STATE OF CONNECTICUT CONNECTICUT SITING COUNCIL

APPLICATION OF CELLCO : DOCKET NO. 495

FACILITY AT 5151 PARK AVENUE,

RESPONSES OF CELLCO PARTNERSHIP D/B/A VERIZON WIRELESS TO CONNECTICUT SITING COUNCIL PRE-HEARING QUESTIONS (SET ONE)

Site Location Map

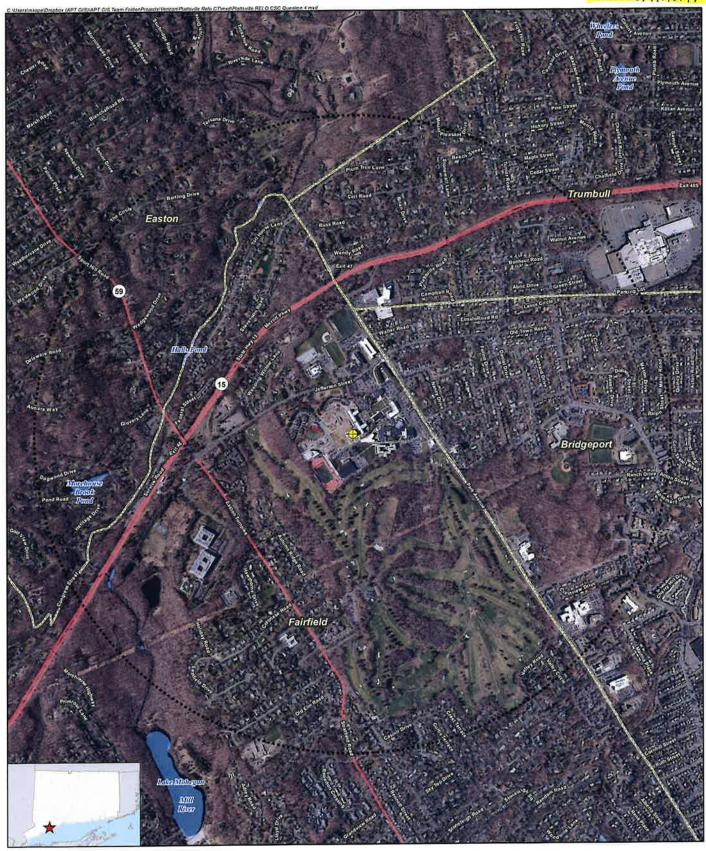
Referring to Application p. iv, revise the image to include the location of Cellco's existing facility. What is the elevation above mean sea level of Cellco's antennas at the existing facility?

Included in Attachment 1 is a copy of the Site Location Map showing the location of Cellco's existing rooftop wireless facility on the SHU campus. The ground elevation around the Toussaint Hall building is 283 feet AMSL. Cellco's antennas are located on the roof at heights of 65 feet above ground level (348 feet AMSL) and 70 feet above ground level (353 feet AMSL).
